Historic Review
Staff Report for a Single Family Home in the Canemah Historic District
September 17, 2019

FILE NO.: GLUA-19-00027/HR 19-05: Historic Review Board review of construction of a new single family residence and detached garage/ADU in the Canemah National Register Historic District.

REQUEST: New construction in the Canemah National Register District. Subfile: HR 19-05.

Site Plan

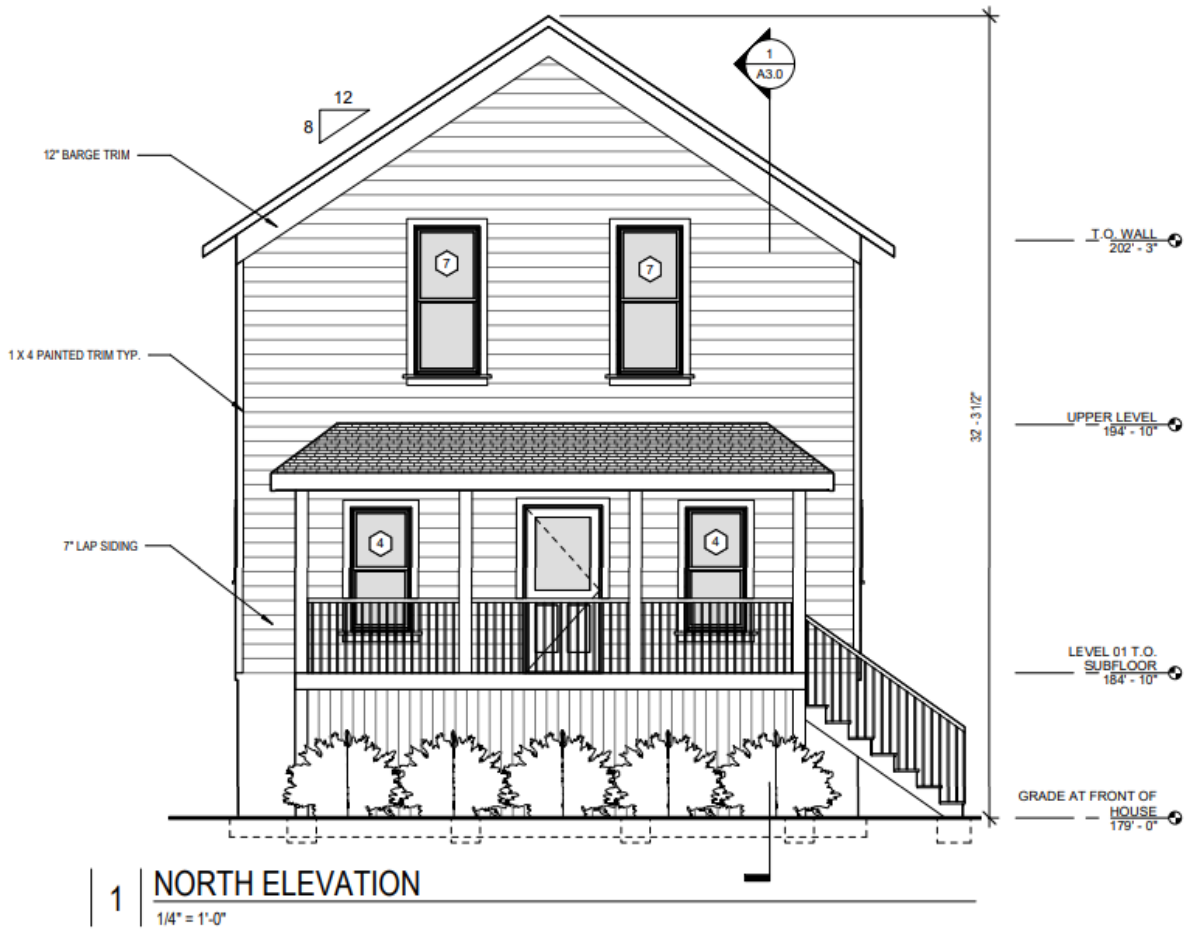
The house is proposed to face 4th Avenue, sitting next to the existing A.E. Davis house, matching the orientation of that home. The front porch is proposed 15 feet from the property line, which is 27 feet from the 4th Avenue street pavement. The A.E. Davis house is approximately 33 feet from the pavement. Thus, the proposed home will also be built closer to the street than the A. E. Davis house by about 6 feet. The home is proposed to be placed 9' 10" from the east property line adjacent to the A.E. Davis House. The A.E. Davis house is approximately 8 feet from the property line, so the separation between the two structures will be almost 18 feet. Staff finds that the 18 foot distance is substantial enough to provide necessary separation between the new structure and the historic home to protect the context of the home.

The impact of this home on the A.E. Davis house comes from the scale and proximity of the home, along with the setback from the street. The home is both wider and taller than the A.E. Davis house, 25 feet wide versus 20 feet, and 32'3" from grade to the roof peak, compared to approximately 25 feet or so height of the A.E. Davis residence. The size differential, combined with the fact that the proposed home is 6 feet closer to the street than the Davis house, creates a dominating effect that impacts the context of the Davis house. Staff finds that if the height of the home were slightly reduced, and the house were placed slightly farther from the street to be more in line with the Davis house, the impact would be reduced. Another way to reduce the impact could be to retain the proposed height and increase the front setback more significantly. Staff recommends a condition of approval to increase the house setback by a minimum amount, or to increase the setback by a few feet along with reducing the mass of the home.

The garage/ADU behind the home is proposed as 528 square feet footprint, 1.5 story, with a 5-foot setback from the neighboring property line. The structure will be closer to the A.E. Davis house, but the rear portion of the A.E. Davis house is not part of the original volume. It is likely that this portion of the A.E. Davis house will be difficult to see from the 4th Avenue ROW after the new proposed home is constructed. Staff finds that the 5 foot setback here is acceptable and will not have an impact on the context of the A.E. Davis house.

The structure is proposed to be setback from the rear property line by 4 feet. The grade difference at the rear of the property is such that a retaining wall is needed, and only the upper story of the structure will be at the rear property line grade.

Page 34 of the design guidelines states that extensive regrading of the lot to raise or lower the main level of the house is not allowed. Limited grading is proposed on the main portion of the lot. The most significant grading is proposed where the garage is proposed. Staff finds that the proposed grading is not extensive.

The applicant's plans show a tree stump in the center of the property where a large tree was recently removed. Other trees on site are proposed to be protected and preserved. The tree that was removed was in the center of the property and could not have been preserved. Page 24 of the design guidelines call for replanting to preserve tree canopy. The applicant shall plant a 2" caliper replacement tree in the

3. The applicant shall increase the house setback to be in line with or behind the front of the A. E. Davis house, or alternatively shall increase the setback by a lesser amount and also reduce the mass of the home by reducing the height by at least 1.5 feet. (P)

1. The applicant shall plant a 2" caliper replacement tree in the side or rear yard; a large native such as Bigleaf Maple, Douglas Fir, Western Red Cedar, or White Oak are acceptable. (P)
2. Incised lumber or pressure treated wood shall not be used on any visible surfaces. (P)
3. All railings, decking and stairs shall be finished to match the house body or trim. (P)
4. The applicant shall plant no less than 5 shrubs in front of the home along the foundation. (P)
5. The applicant shall utilize simple vernacular styled exterior lighting.(P)

Front elevation

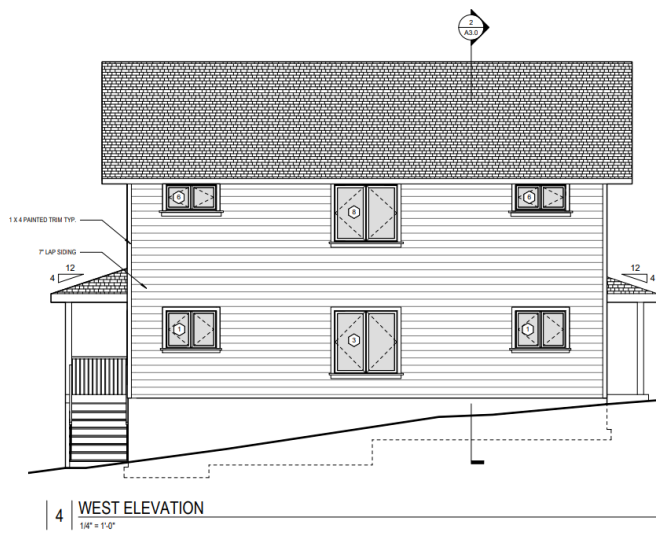
The height of the home, while it appears 1.5 stories due to the use of scissor trusses, is in fact significantly taller than other vernacular homes in Canemah. The proposed height is 32 feet 3 inches. The design guidelines on page 38 state that residential buildings that vary more than 20% from heights of the historic neighborhood context are not allowed unless approved by HRB. Other 1.5 story Vernacular homes include the Nutall house at 803 5th Avenue, the Davis house at 702 4th avenue, the Rakel residence at 210 Hedges, and the Graves house at 211 5th Avenue, and the Draper house at 808 1st Avenue. The Graves and Draper house may be closer to 30 feet in height, but the other homes are likely closer to 24 feet in height. The HRB may wish to reduce the height of the proposed home to bring it closer in line with the historic home heights in the district, considering that it is located right next to one of the historic contributing Vernacular homes.

The proportions of the house are appropriate and meet the design guidelines. The width of the home is 25 feet. Height measured to the eave is 17 feet from the ground floor. When measured from grade, the height is 23 feet to the eave, which is closer to the maximum 1:1 ratio. The house is fairly wide for a Vernacular style, however, the narrow windows mitigate for the width.

The plans show an additional 5'2" feet in height of mass underneath the front porch. Landscaping in the form of 5 shrubs is proposed to visually shield the massing. The applicant shall plant no less than 5 shrubs in front of the home along the foundation.

The applicant proposed vertical siding under the porch, which is not compatible with the district. Under the front porch, the applicant shall use 90 degree perpendicular wood lattice or other architectural styles appropriate for house, painted darker than the color of the house to blend in with the surroundings.

The exterior is proposed to be covered with 7" reveal smooth fiber cement lap siding, with 1x4" painted trim and a 12" barge board. Exterior decoration is simple, no architectural detailing is proposed. The windows on the front façade are 1:1 and double hung. The front door is shown as half-lite. The side elevations include casement and awning paired windows. While these are not typical of the vernacular style, the limited use of such windows has been deemed compatible.

5. Under the front porch, the applicant shall use 90 degree perpendicular wood lattice or other architectural styles appropriate for house, painted darker than the color of the house to blend in with the surroundings.

West and south elevations

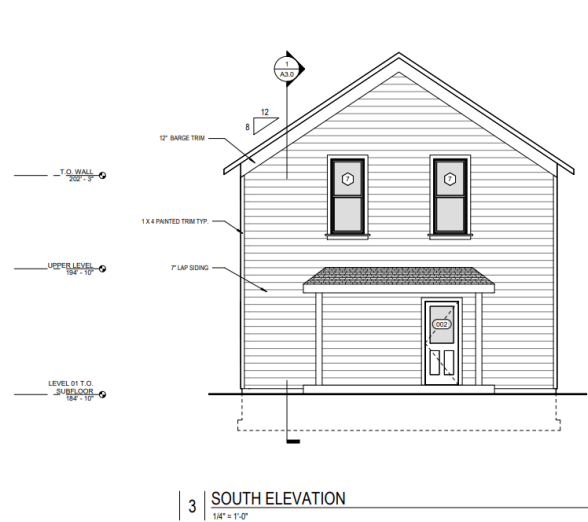
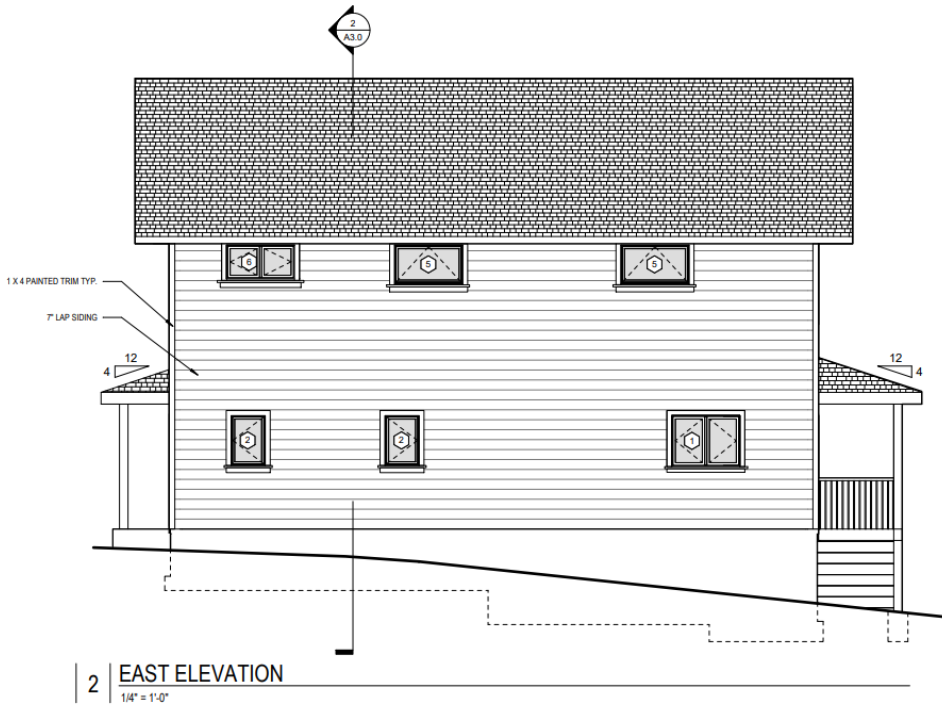
The rear elevation includes 1 over 1 windows and one half lite door. Doors are proposed to be wood or fiberglass. Minor changes to window location on the side and rear facades will be acceptable and may be approved at a staff level prior to building permit issuance.

4. Minor changes to window location or size on the side and rear facades will be acceptable and may be approved at a staff level prior to building permit issuance. (P)
